Product Change Notification (PCN)

PCN #: 7A-2023-R1

DATE: October 24, 2023

Laird Part Number: 450-0159R/450-0159C

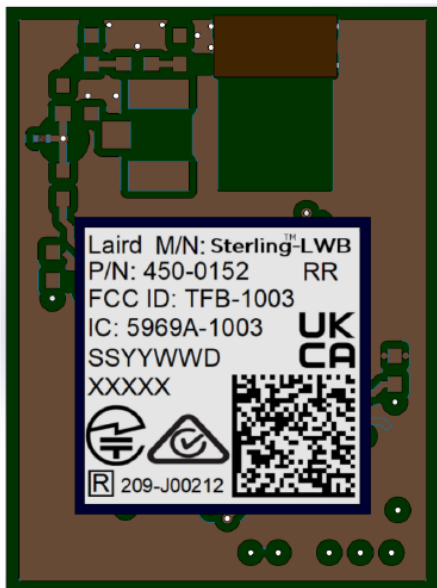
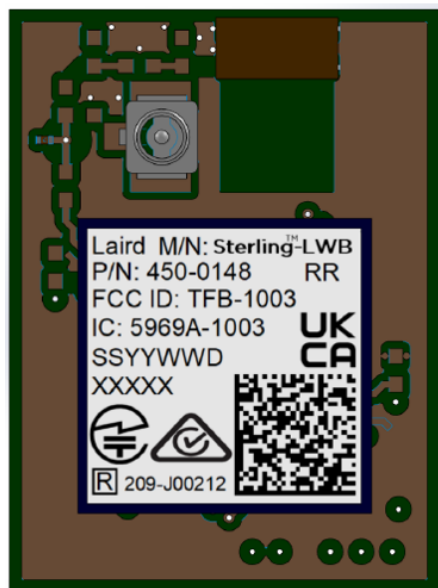
The module with B0FB15 MAC OUI will have an example barcode readout such as “450-0159,1 ,0523302,00001”, indicating that modules with a date code of 0523302 or any date code later than week 30 of 2023 will possibly have B0FB15 MAC OUI.

Laird Part Number: 453-00012R/453-00012C

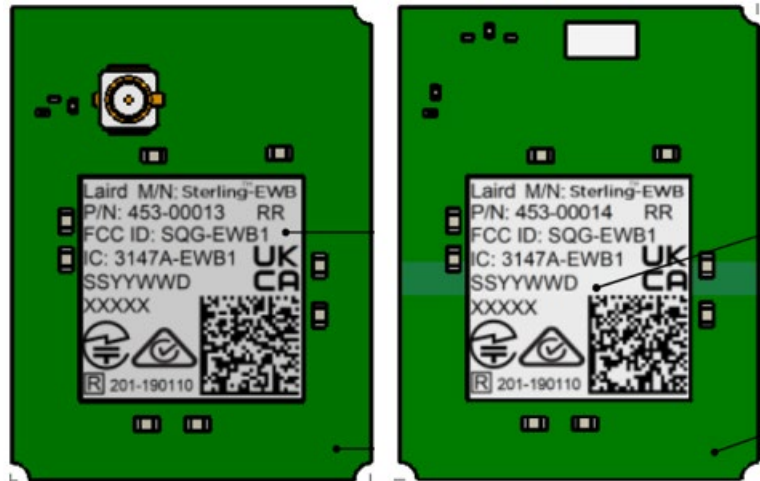
The module with B0FB15 MAC OUI will have an example barcode readout such as “453-00012,1 ,0523302,00001”, indicating that modules with a date code of 0523302 or any date code later than week 30 of 2023 will possibly have B0FB15 MAC OUI.

**Laird Part Number: 453-00013R/453-00013C/453-00014R/453-00014C**

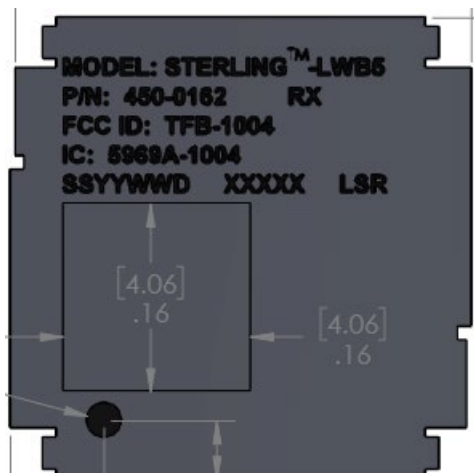
The module with B0FB15 MAC OUI will have an example barcode readout such as “453-00013,1 ,0523302,00001” or “453-00014,1 ,0523302,00001”, indicating that modules with a date code of 0523302 or any date code later than week 30 of 2023 will possibly have B0FB15 MAC OUI.

Laird Part Number: 450-0162R/450-0162C

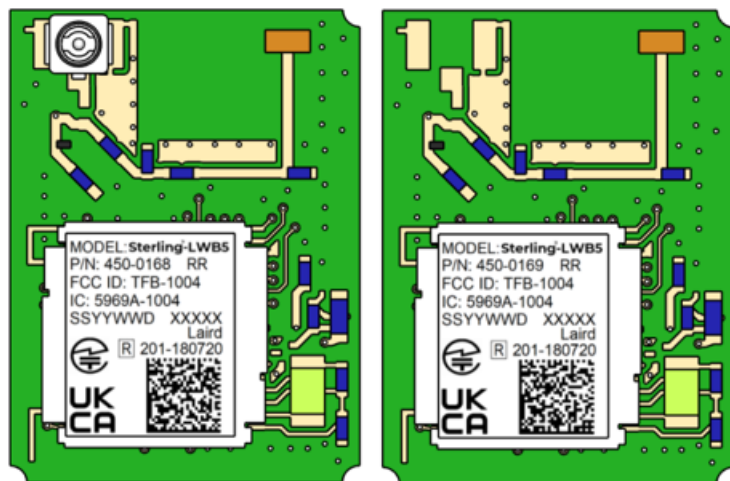
The module with B0FB15 MAC OUI will have an example barcode readout such as “450-0162,1 ,0523302,00001”, indicating that modules with a date code of 0523302 or any date code later than week 30 of 2023 will possibly have B0FB15 MAC OUI.

**Laird Part Number: 450-0168R/450-0168C/450-0169R/450/0169C**

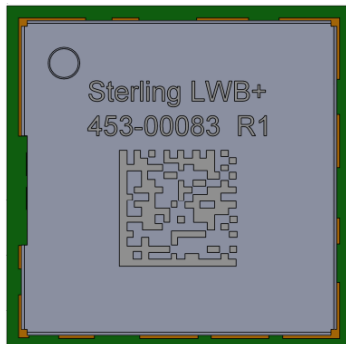
The module with B0FB15 MAC OUI will have an example barcode readout such as “450-0168,1 ,0523302,00001” or “450-0169,1 ,0523302,00001”, indicating that modules with a date code of 0523302 or any date code later than week 30 of 2023 will possibly have B0FB15 MAC OUI.

Laird Part Number: 453-00045R/453-00045C/453-00045-K1

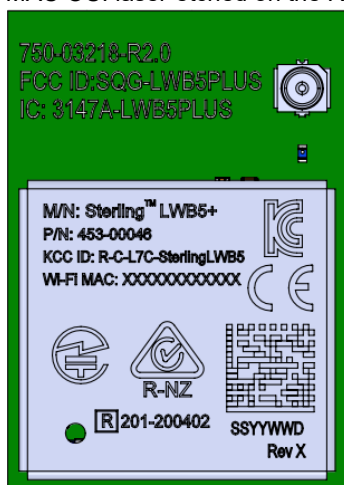
MAC OUI laser-etched on the RF shield and embedded in the barcode will change from C0EE40 to B0FB15

**Laird Part Number: 453-00046R/453-00046C/453-00046-K1**

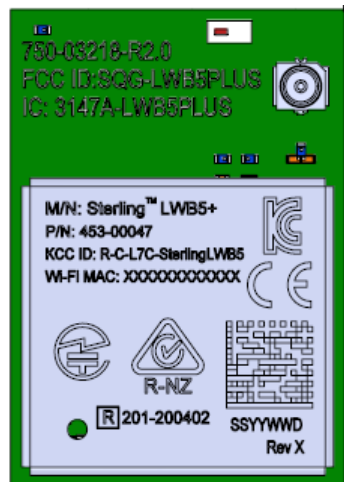
MAC OUI laser-etched on the RF shield and embedded in the barcode will change from C0EE40 to B0FB15
